FINAL REPORT

Clarksburg - Ten Mile Creek Area Sewer Facility Study

WSSC Contract PM0007A07

Washington Suburban
Sanitary Commission

Figure 1-1 Project Study Area in Seneca Creek Basin

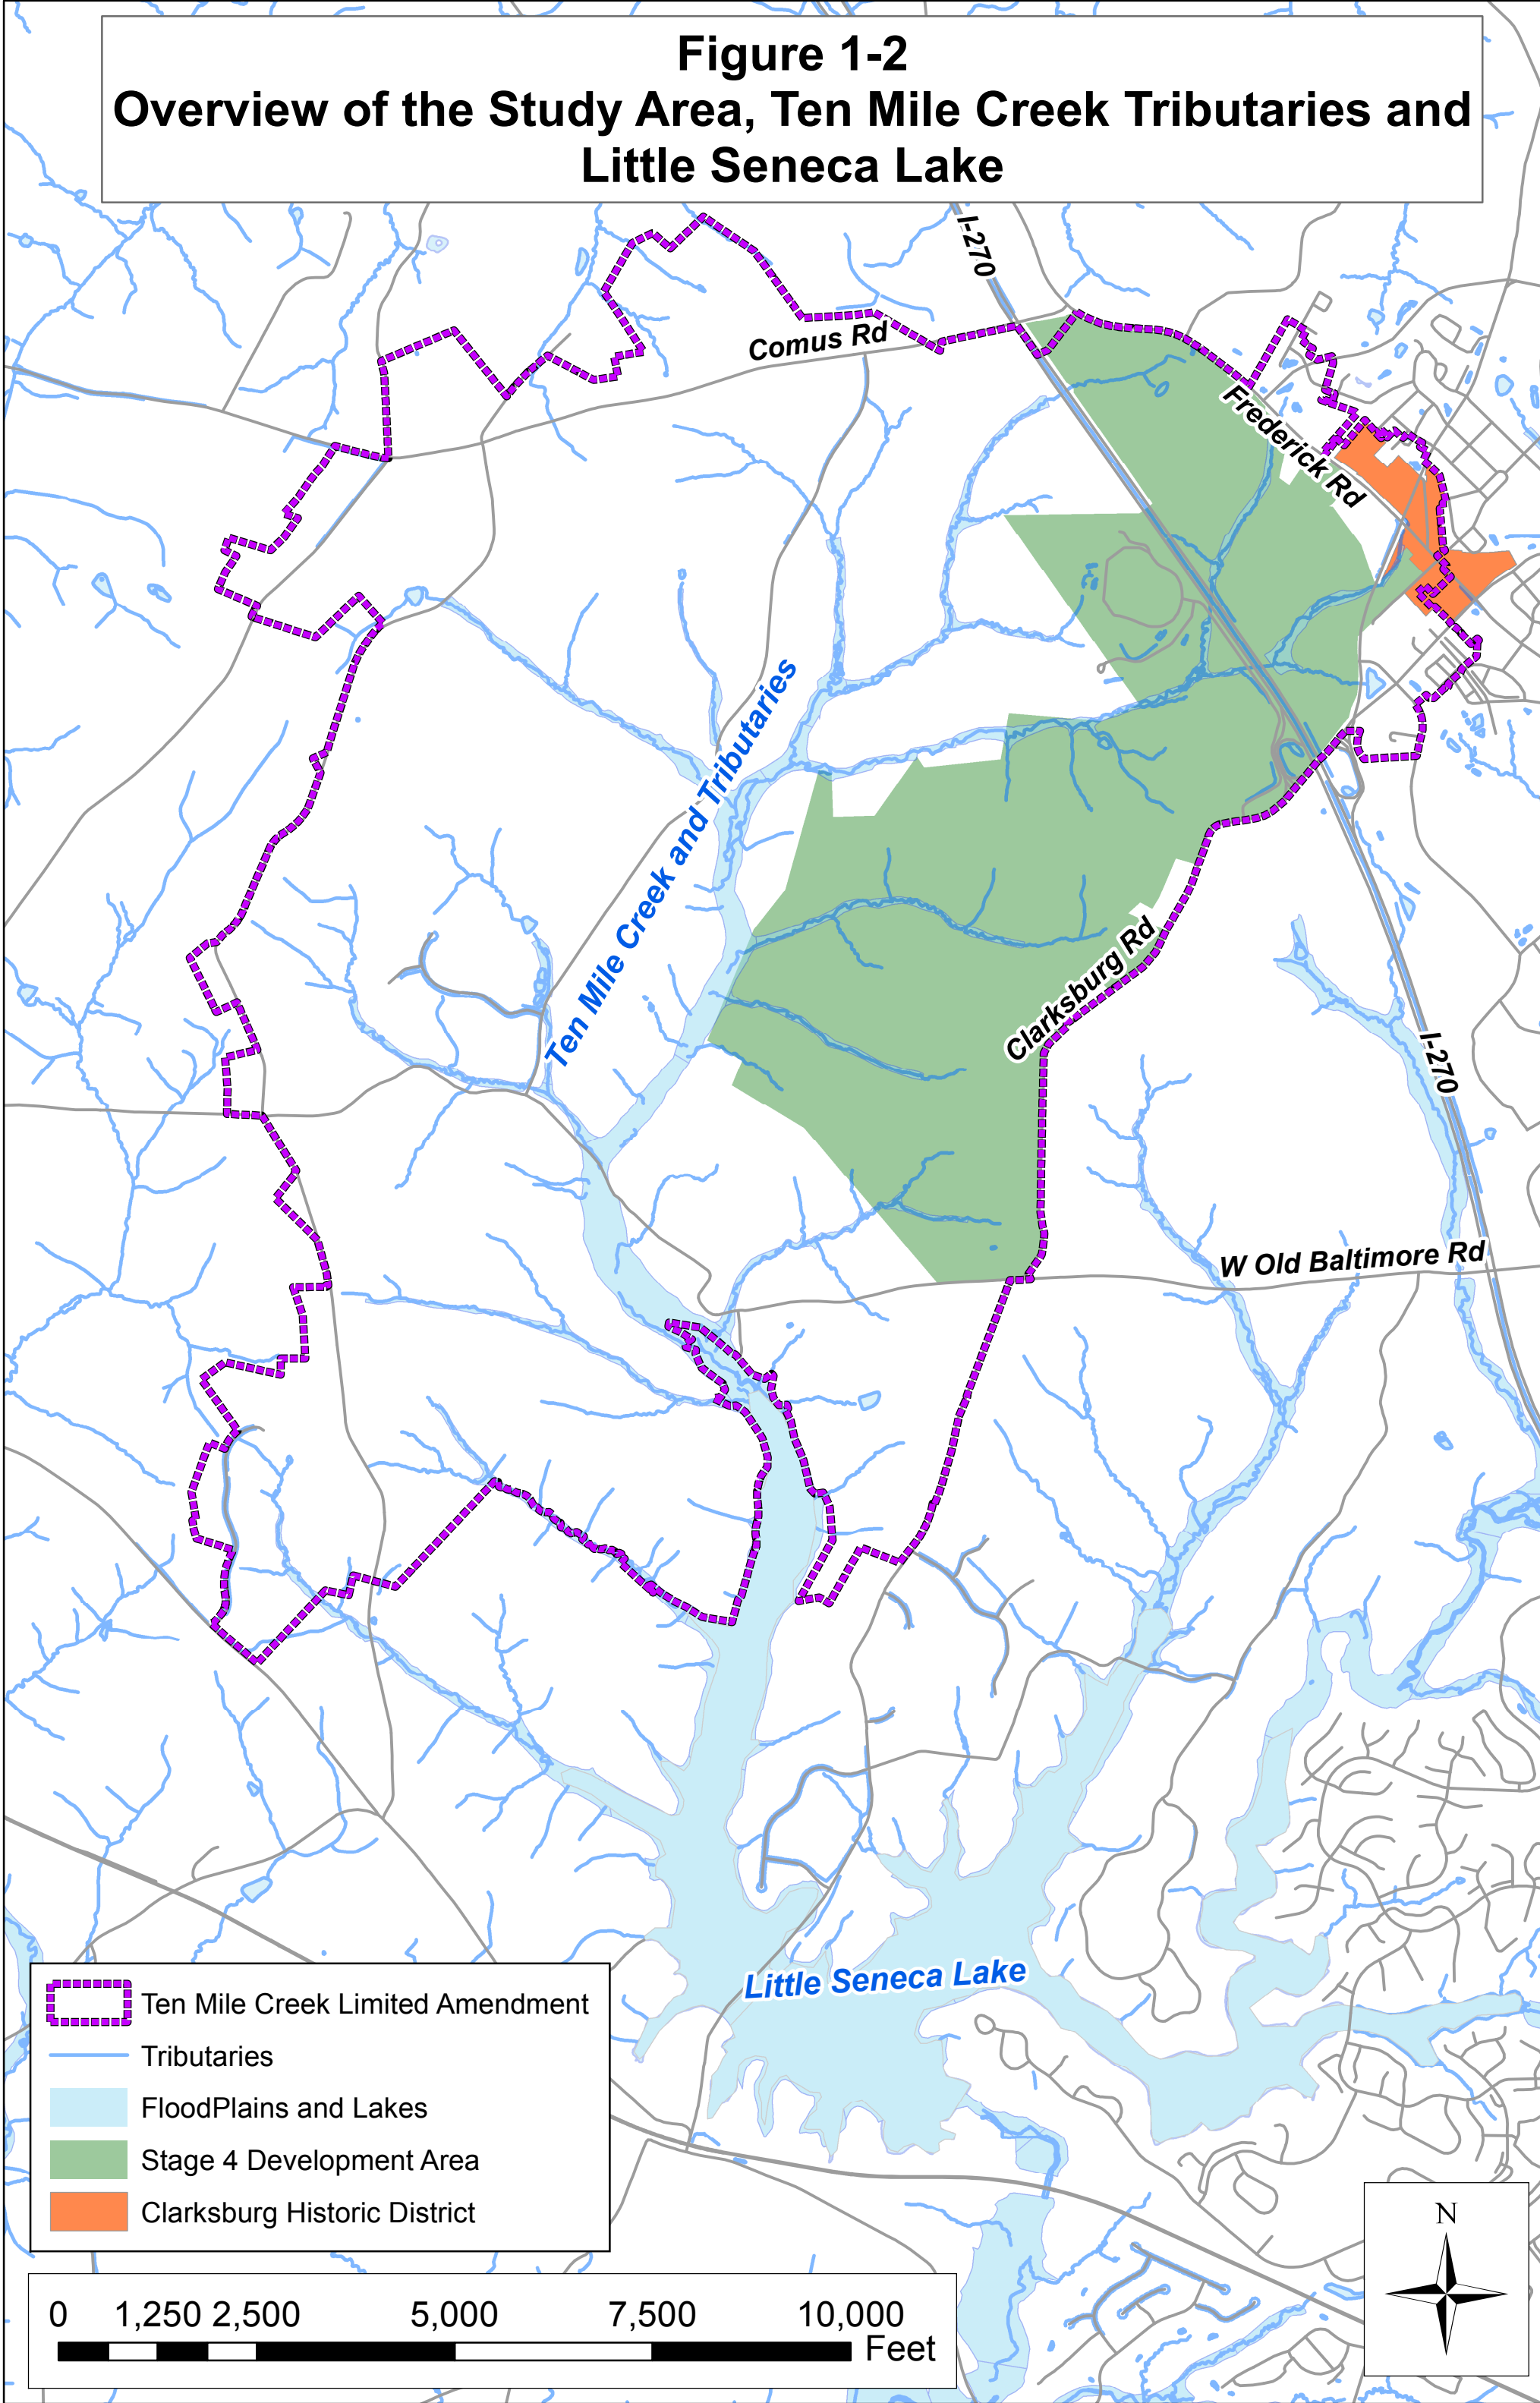
11	12/18/2015	Dave Lake (MCDEP)	<i>Figure 1-1: The Project Study Area need a companion map that identifies the TMC and tributaries as Figure 1-1 does for the downstream areas.</i>	An additional companion map (<i>New Fig 1-2</i>) is included in the Final Draft Report to address the comment.
12	12/18/2015	Dave Lake (MCDEP)	<p>Figure 1-2:</p> <ul style="list-style-type: none"> <i>This figure should include all of the Study Area and not be partially blocked by the table heading. It appears map legend for the Historic District Vicinity Properties is not accurately depicted.</i> <i>Legend colors and designations should align better.</i> 	Figure 1-3 (<i>Figure 1-2 in Working Draft Report</i>) of the Final Draft Report includes extent and legend modifications to address comment.
13	12/18/2015	Dave Lake (MCDEP)	<i>Figure 1-4: Cabin Branch is two different colors with no explanation.</i>	Figure 1-4 (of the Working Draft Report) has been deleted from the Final Draft Report since it relies on outdated information.

Figure 1-3 Study Area and Downstream WSSC Sewers

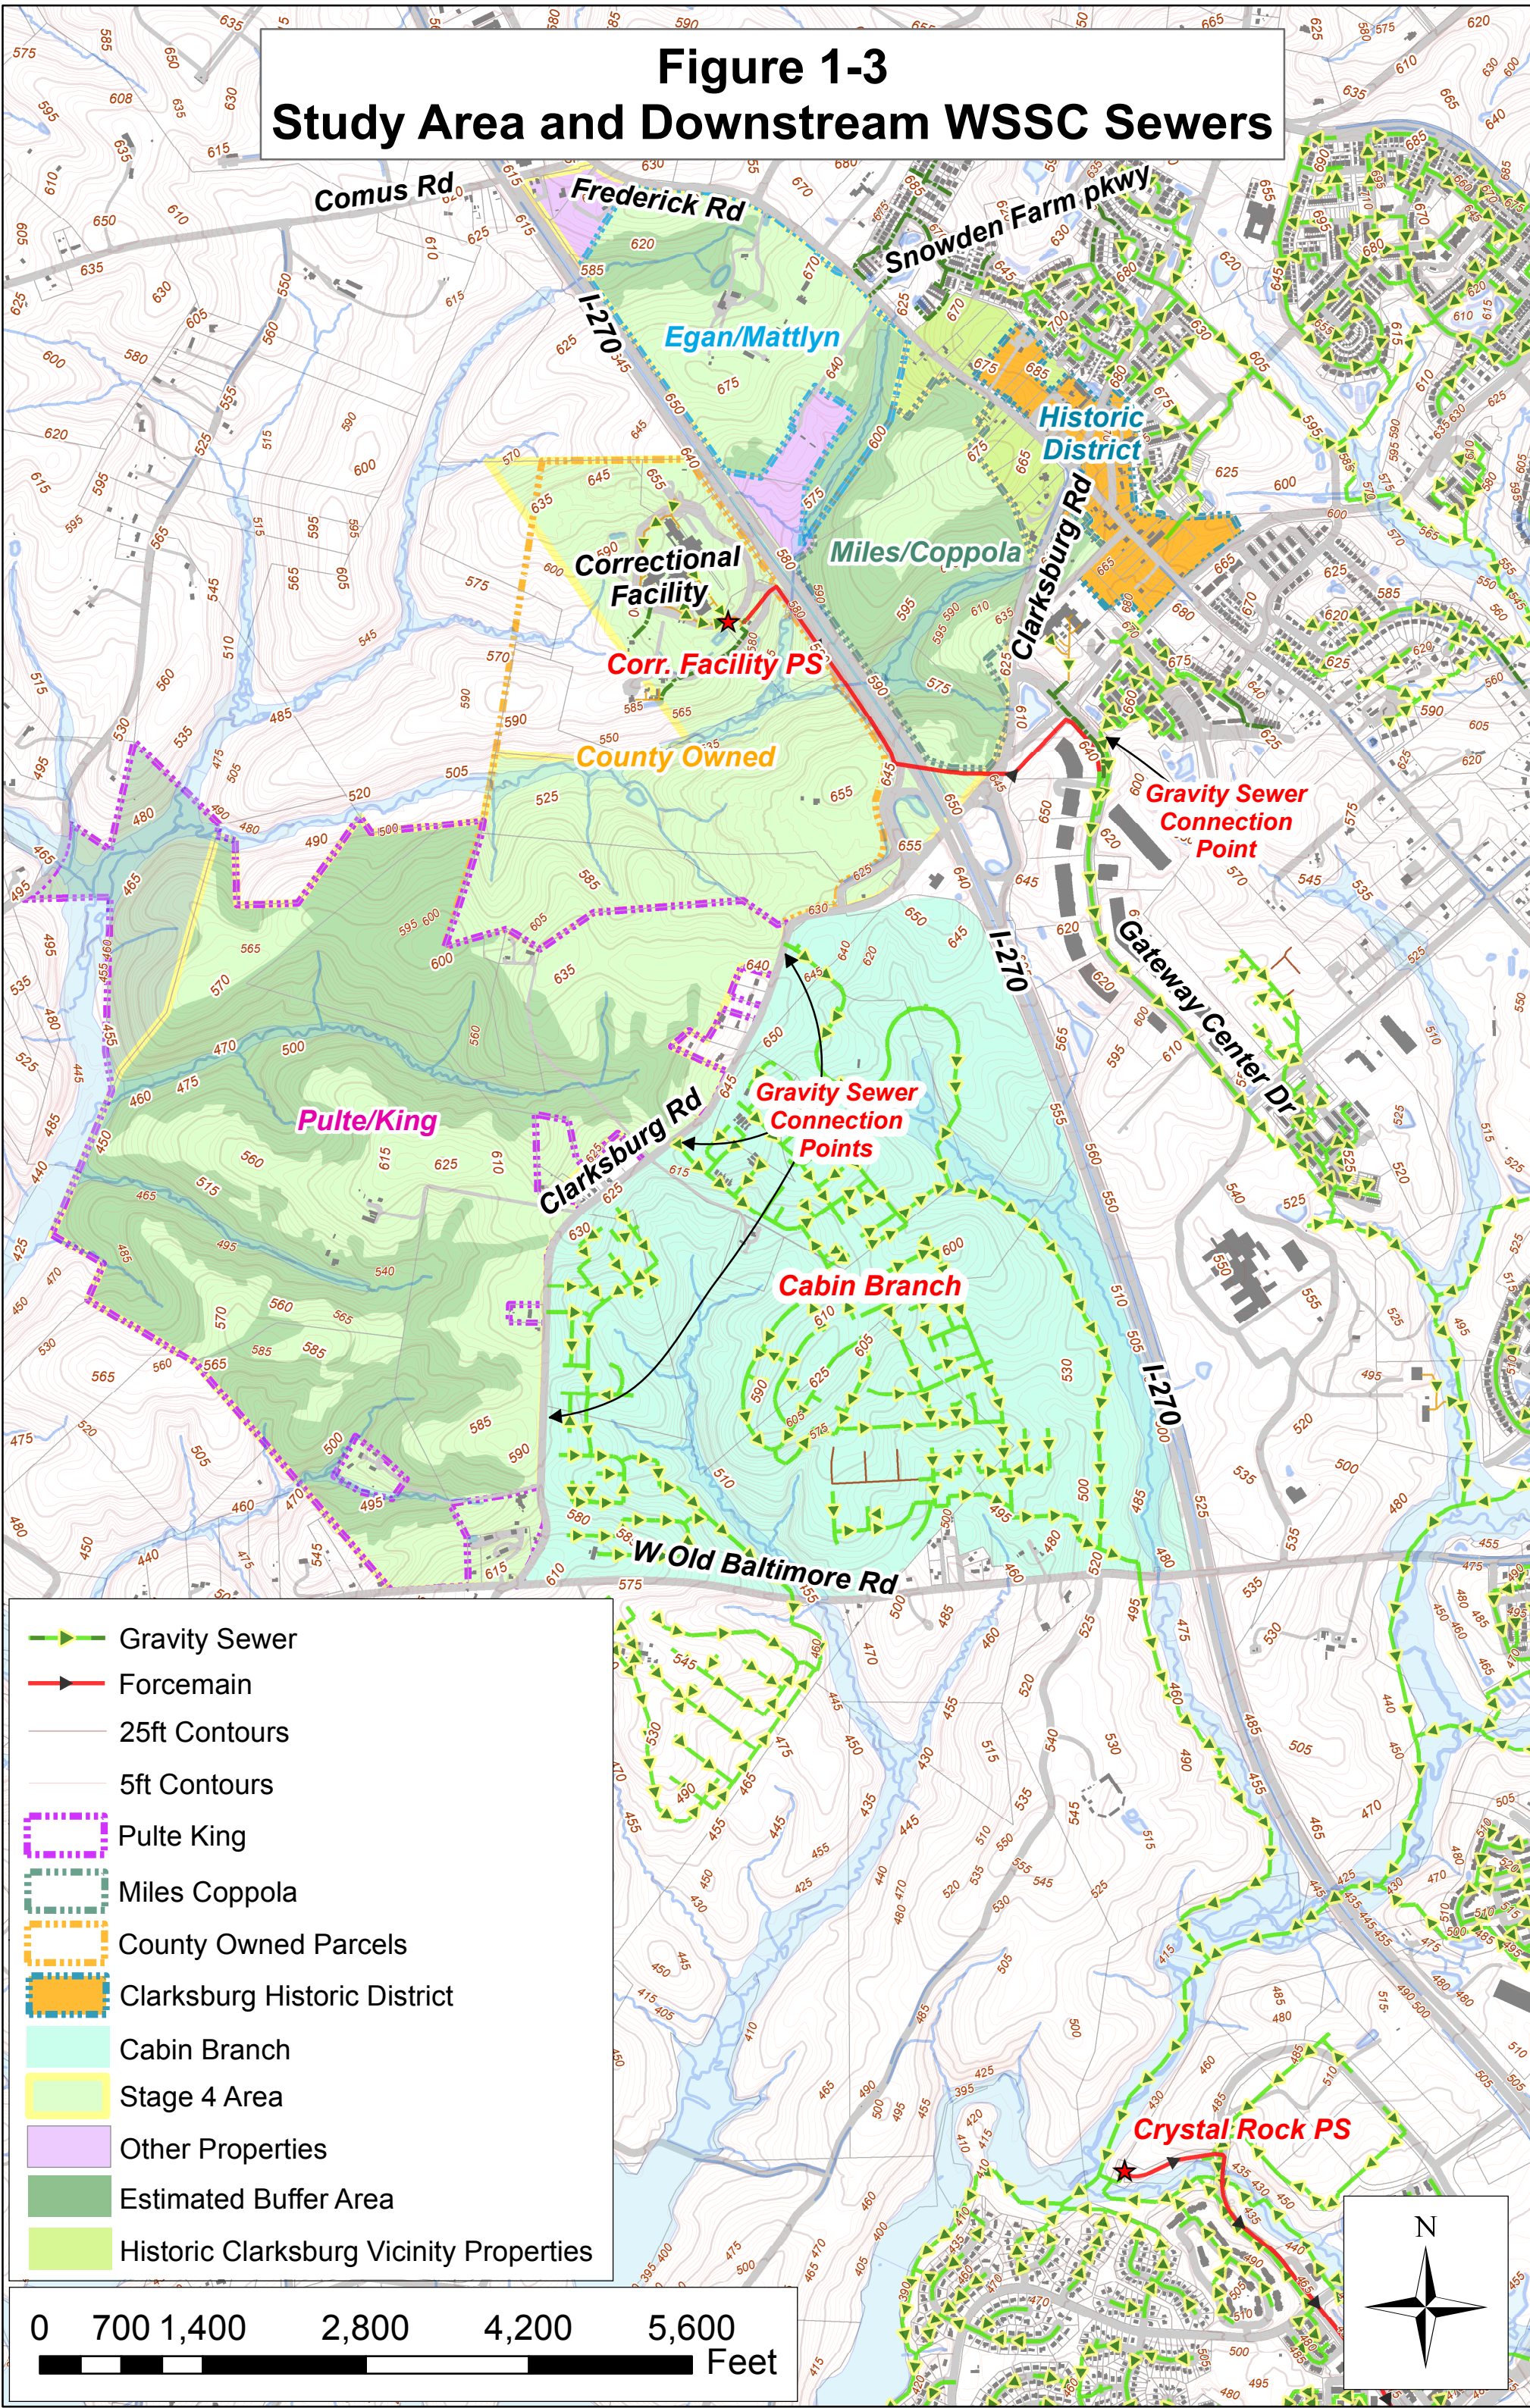
Number	Date	Representative/Party	Comment	WSSC Response
		Anne James, Cathy Wiss, (CAC Members)	<i>d) In Figure 1-3, WSSC shows anticipated bottlenecks in the gravity sewers along Gateway Center Drive. What are the plans to alleviate them?</i>	When new development plans are submitted to WSSC for review and approval, a Hydraulic Planning Analysis (HPA) is conducted to review available capacity in the downstream sewers and determines the necessity for a relief sewer. At this point in the process WSSC does not have the necessary information to determine when such a relief sewer may be needed.
42	12/21/2015	Katherine E. Nelson Planner Coordinator M-NCPPC	<i>1. Section 1, Page 1-3 - County Owned Properties – 220 forested acres of correctional facility are protected by a permanent conservation easement. Also, the future planned expansion is limited in scope and takes place within the current cleared area of the site. The County owns two vacant parcels that are not part of the correctional facility.</i>	Section revised in Final Draft Report to address the comment.

**Figure 4-1
Comparison of Forcemain Lengths**

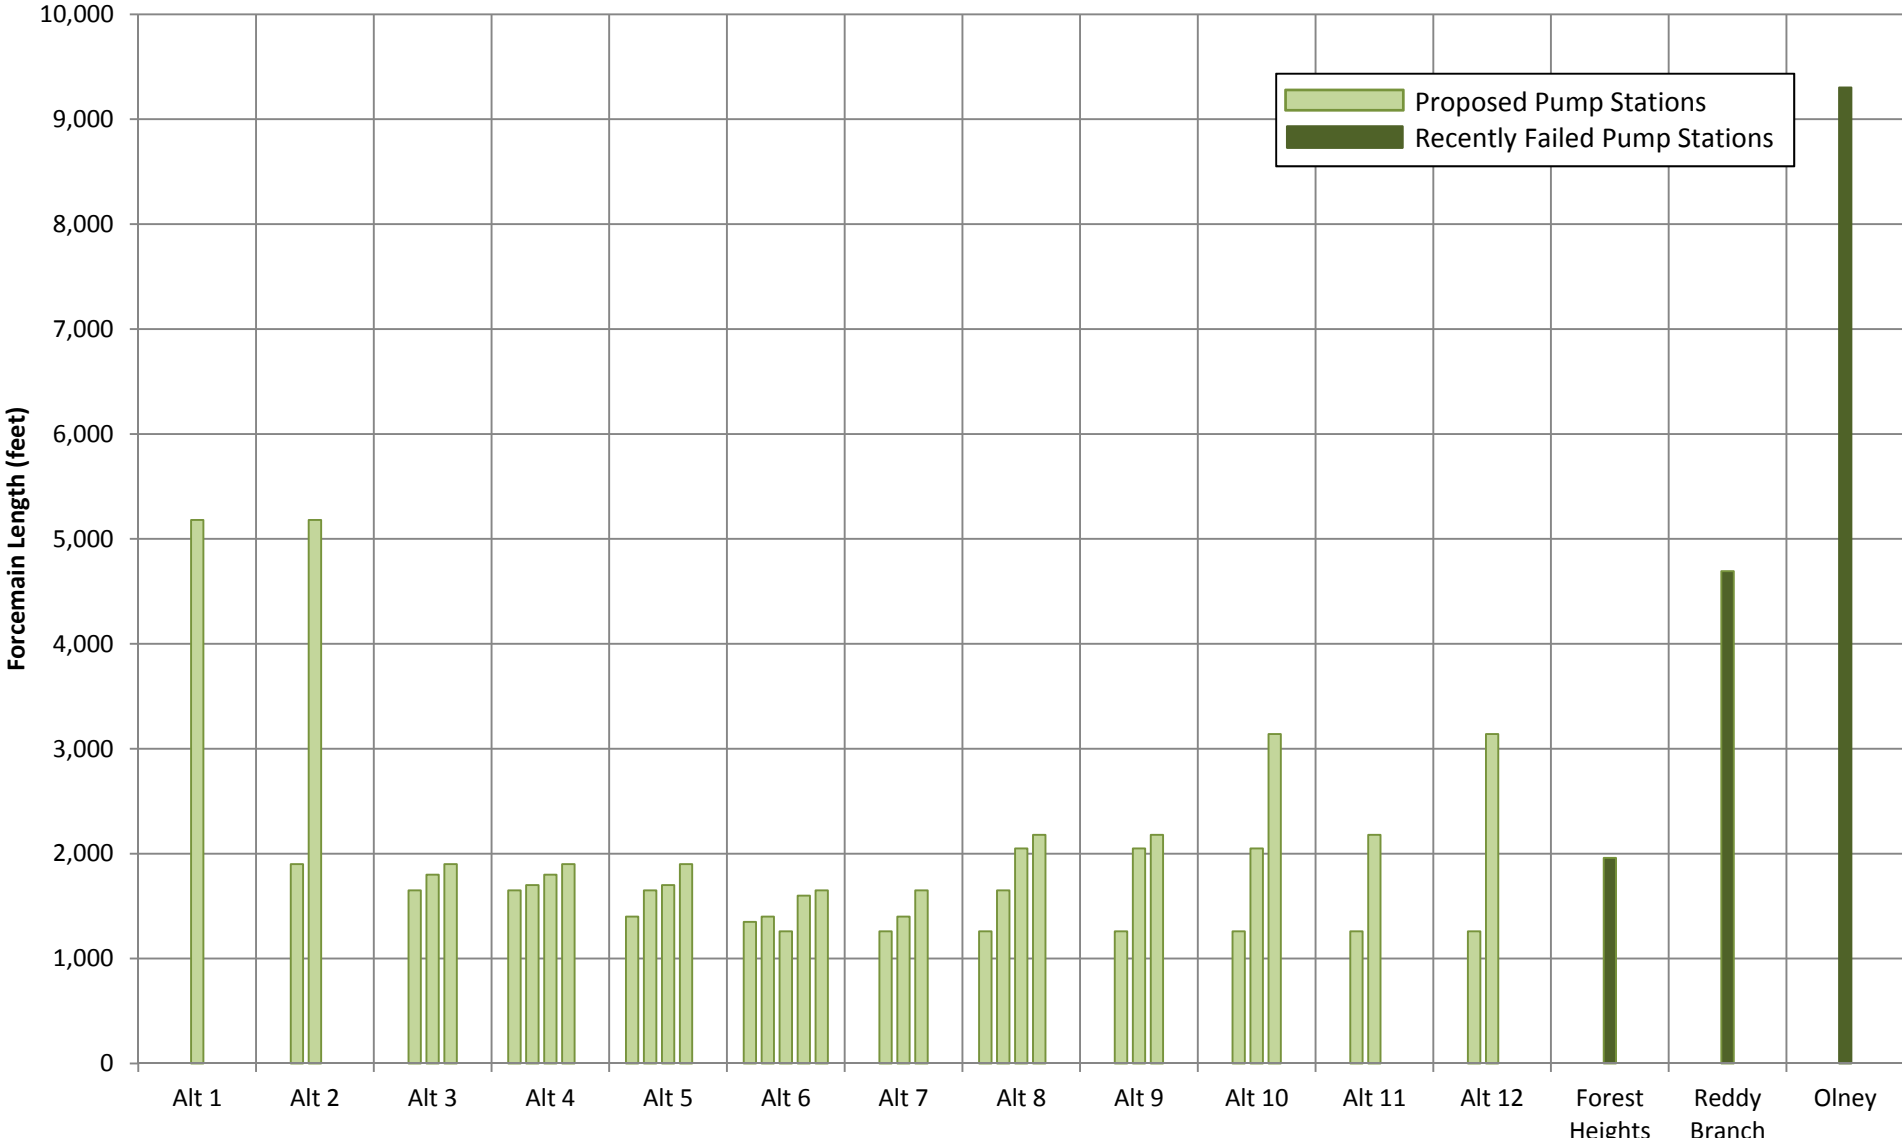
2	12/21/2015	Katherine E. Nelson Planner Coordinator M-NCPPC	<i>11. Figure 4-1 and 4-2 pages 4-14 and 4-15 – Should identify “recently failed” pump stations rather than “existing” pump stations. It implies that these are the only pump stations in the WSSC system.</i>	Revised figures 4-1 and 4-2 in the Final Draft Report to address the comment.
53	12/21/2015	Katherine E. Nelson Planner Coordinator M-NCPPC	<i>12. Figure 4-3 and 4-4 (the Preferred Approaches) – The graphics reference “Grinder Systems” and “grinder pump solution”, but the legend identifies “Low Pressure Sewer”. One term should be used when describing these systems, both on these graphics and in the text.</i>	Revised figures in the Final Draft Report to address the comment.
54	12/21/2015	Katherine E. Nelson Planner Coordinator M-NCPPC	<i>13. Criteria for the successful use of low pressure sewers should be provided by this study. At a minimum, examples of the successful use of low pressure sewers should be provided.</i>	Refer to WSSC SP ENG-04-10, Grinder Systems Policy and Procedure, as to successes we have achieved based on experience and meeting policy requirements.
